MONTGOMERY COUNTY HISTORIC PRESERVATION COMMISSION
STAFF REPORT

Address:	12 Hesketh St., Chevy Chase	Meeting Date:	1/11/2017
Resource:	Contributing Resource Chevy Chase Village Historic District	Report Date:	1/4/2017
Applicant:	Neil Cullen (Jason Gagen, Architect)	Public Notice:	12/28/2016
Review:	HAWP	Tax Credit:	N/A
Case Number:	35/13-17A	Staff:	Michael Kyne
PROPOSAL: Rear addition and window replacement

FRONT ELEVATION
A-2 1/2" x 1/4" = 1" = 0"

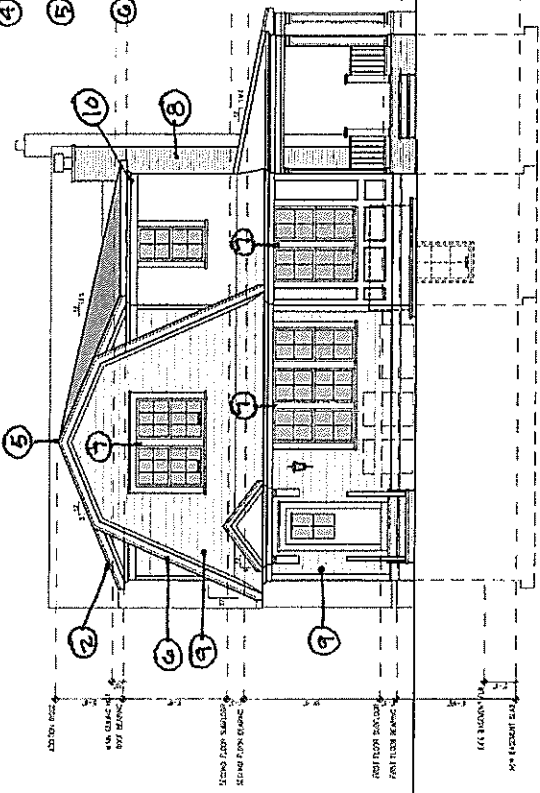
1. The proposed replacement roofing materials will be architectural asphalt shingles, with final review and approval delegated to staff
2. The proposed front door replacement is not approved.
3. Window and door details will be submitted, with final review and approval delegated to staff.

The *Guidelines* state that "[d]oors should be subject to moderate scrutiny if they are visible from the public right-of-way, lenient scrutiny if they are not." The applicant has provided photographs of the existing front door, which suggests that it is likely historic. No documentation has been provided to indicate that the existing front door is severely deteriorated and in need of replacement, and staff recommends that the proposed front door replacement not be approved.
